Project Name and Address
WHITE COTTAGE FARM
16910 THOMPSON RD
COLORADO SPRINGS, CO 80908
OWNER: SHAWNA SCHOTANUS
TAX SCHEDULE NUMBER: 51190-00-007
FILING: 51190 000 07
ZONING: RR-5

Project
SITE DEVELOPMENT & LANDSCAPE PLAN
Date
6/7/2021
Scale
1/32" = 1'-0"
SHEET SIZE: 24x36

Sheet
L102

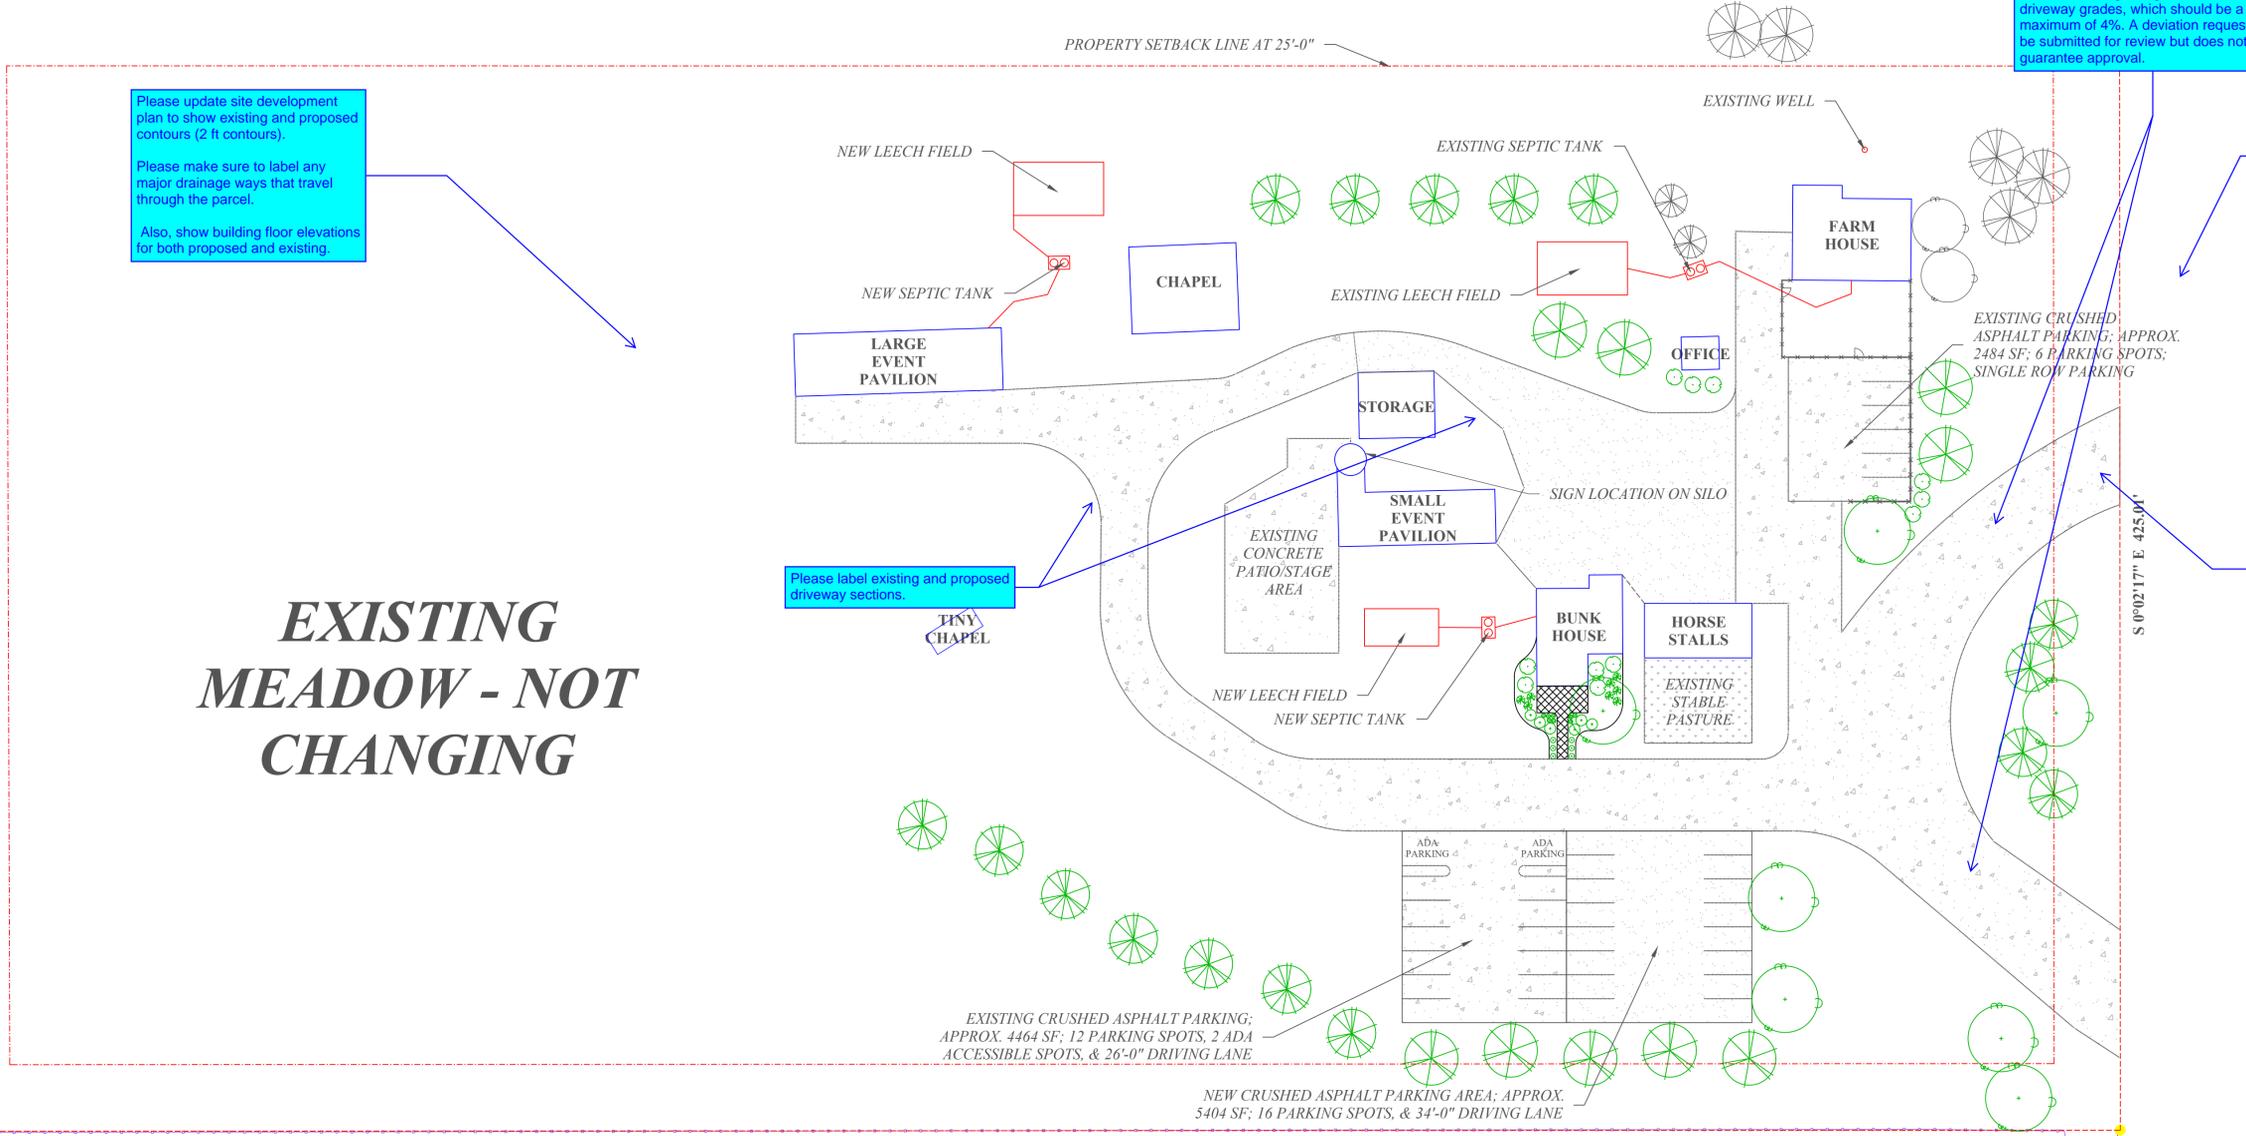
Provide a 1x2 inch signature block for the PCD Director to sign.

Please see VA-216 for any additional comments on site plan.

Per traffic memo submitted with this application, driveway access point shall be aligned at 90 degrees to Thompson Road. Please reconfigure driveway access point to align at 90 degrees to Thompson Road. Driveway shall also be compliant with the ECM criteria regarding commercial driveway grades, which should be a maximum of 4%. A deviation request can be submitted for review but does not guarantee approval.

Please update site development plan to show existing and proposed contours (2 ft contours). Please make sure to label any major drainage ways that travel through the parcel. Also, show building floor elevations for both proposed and existing.

Please label Thompson Road.

There are no driveway permits on file. Please apply for driveway permit by contacting Petra Rangel at petrarangel@elpasoco.com

The building footprint for all structures need to be depicted and labeled to include the proposed use(s), floor area, and height. The setbacks of all building footprints dimensioned from all property lines need to be shown.

No ADA spaces have been identified. Will there be any ADA spaces?

Please show existing and proposed easements.

Please add "PCD File No. PPR-21-028" to the bottom right corner.

Please label scale dimension.
